Determination 2010/116

The issuing of a code compliance certificate for a house at 12 Fairhaven Walk, Wade Heads, Whangaparaoa

Figure 1: Site plan showing the house and the overland flow paths

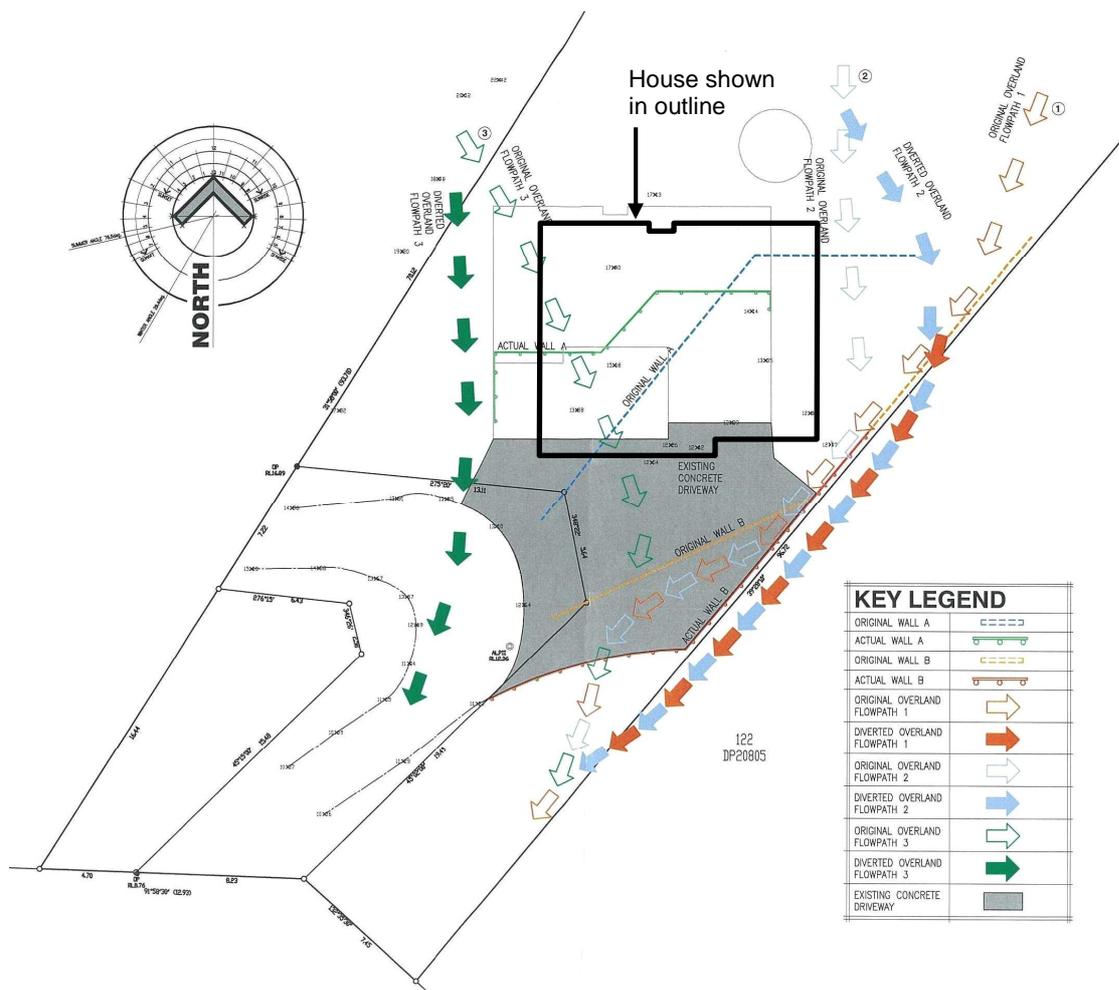
- There are no silt control measures in place.
- It appears that an overland flowpath [overland flow path 2 in Figure 1] used to go through the earthworks area that has now been diverted to the minor watercourse at the eastern end of the site.

- 5.2.1 The expert inspected the site and made the following comments:
- The excavation cut behind the building platform is not retained.
 - The three distinct overflow paths through the site have been altered in some way by the building work and this has led to some blockages, subterranean activity, and scouring on the site.

- Clause E1 had not been complied with regard to:
 - the lack of provision to accommodate the passage of surface water through the property to ensure that surface water does not enter the building
 - the non-avoidance of damage or nuisance to other property caused by surface water being diverted by the buildings and the sitework
 - the lack of surface water outfall protection.
